Groundwater Application Review Summary Form

Application # G- 18841

TO: Water Rights Section Date 9/4/2019
 FROM: Groundwater Section Aurora C Bouchier
 Reviewer's Name
 SUBJECT: Application G- 18841 Supersedes review of na
 Date of Review(s)

A. GENERAL INFORMATION: Applicant's Name: Clayton Strasser County: Deschutes

Water-Level Trends in Nearby Wells

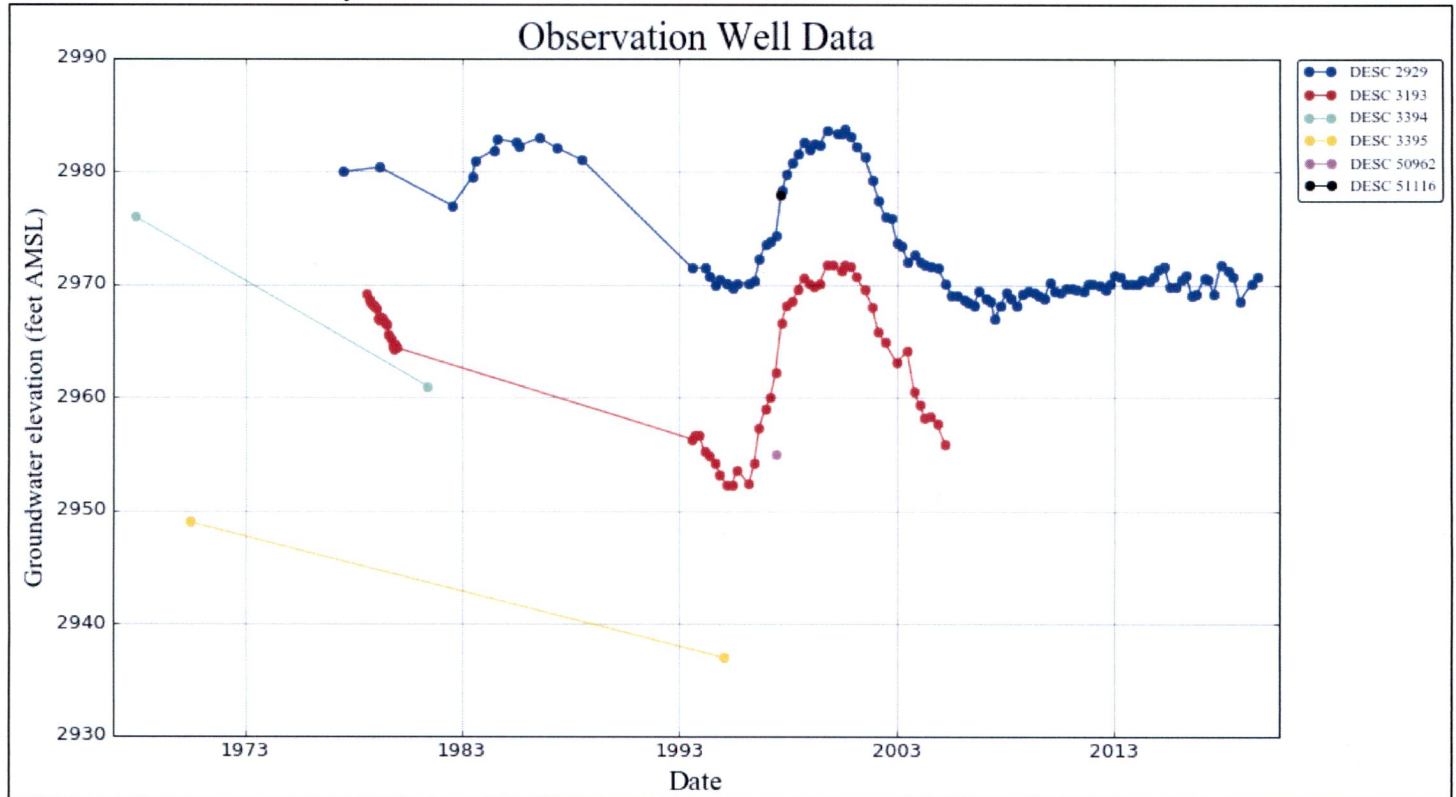
The nearest State Observation Well (DESC 3193) is located less than ½ mile to the northwest. Unfortunately water-level measurements at DESC 3193 ceased in 2005. The nearest State Observation Well currently being measured (DESC 2929) is located approximately 5 miles to the northwest. During the periods of overlap, the hydrograph of the wells show a similar pattern. Historically, DESC 2929 appears to have been in dynamic equilibrium with the long-term trend displaying a decadal-scale water level fluctuation that is coincident with climate cycles. The decadal fluctuation has a maximum amplitude of approximately 15 feet. Since 2000, the water level has dropped about 15 feet, with a slight increase since 2005. The decline is likely mostly due to decreased recharge of a climatic cycle. However, since 2006 water level trends in DESC 2929 have deviated from climate cycle trends. The divergence from climate driven water level trends in DESC 2929 is possibly due to decreased canal leakage and increased groundwater pumping.
